RECREATIONAL AVIATION AUSTRALIA INC

AIRCRAFT AIRWORTHINESS NOTICE

AIRWORTHINESS NOTICE IDENTIFICATION NUMBER : 041207-1

X-Air HANUMAN

BEFORE

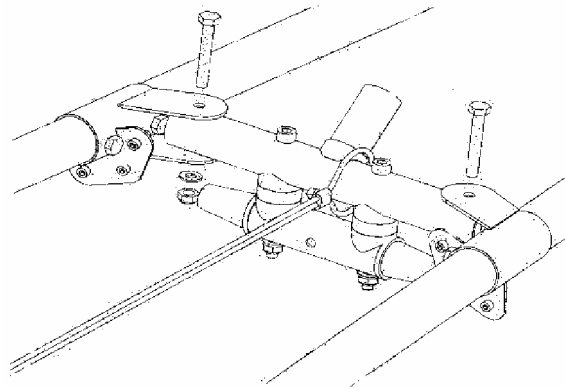
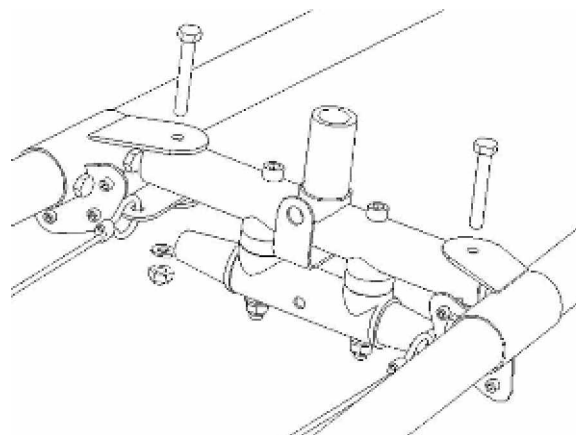
Background: A change in design with regard to the shoulder harness attachment point has been noted through the assembly manual.

Discussion: The previous attachment of the shoulder harness to the cross tube which connects the vertical stabiliser is considered to be less effective than the current design, attaching the shoulder harnesses to the longeron / cross tube joint via separate securing tangs for each harness.

Compliance: Before next flight, owners of X-Air Hanuman's are to check that the shoulder harness is attached in a manner conducive to the latest assembly manual available from the Rand-Kar website or their associated distributor's websites. Register compliance with AN 041207-1 in the aircraft log book.
